RE: Nine Mile Point Unit 1
Docket No. 50-220
DPR-63

Subject: *Response to Dr. S. Penn Regarding Core Shroud Evaluations, Nine Mile Point Unit 1 (NMP1)*

Figure 1 Yield Strength Versus Neutron Fluence

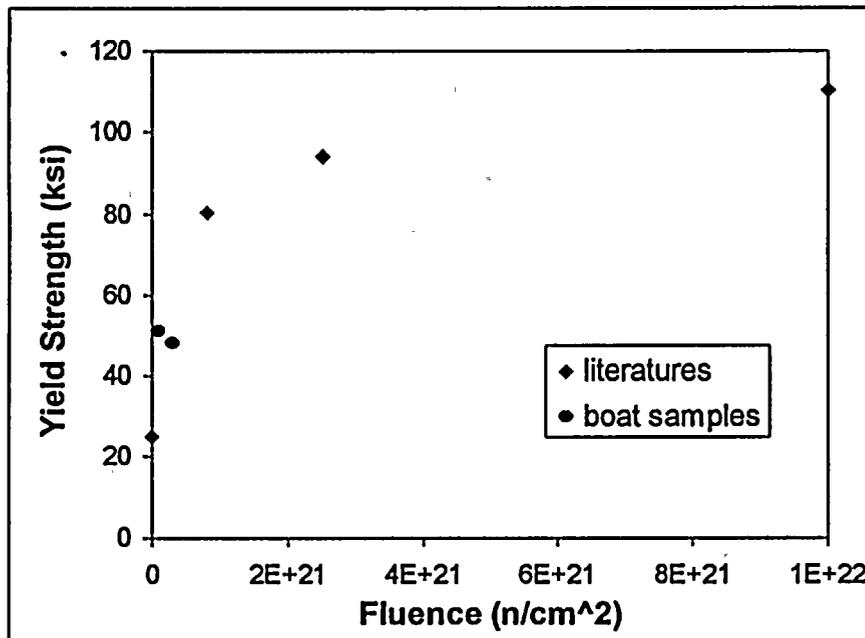
Dr. Penn correctly pointed out that that the yield strength rises rapidly with fluence and then tapers off and asymptotically approaches a value below the ultimate strength. For Type 304 stainless steel, the change of yield strength versus neutron fluence is depicted in Figure 1. Please note the last data point at E22 neutrons/cm² is obtained from Pressurized Water Reactor (PWR) baffle bolts (made of Type 347 stainless steel) tensile pull performed by FTI at a PWR reactor site and is for information only. It is noted that in the neutron fluence range of interest, the yield strength increases rapidly with increasing fluence. The argument that the boat samples might have received larger than the calculated fluences due to the fact that boat samples yield strength might have been in a range where the yield strength tapers off and asymptotically approaches a value is not valid.
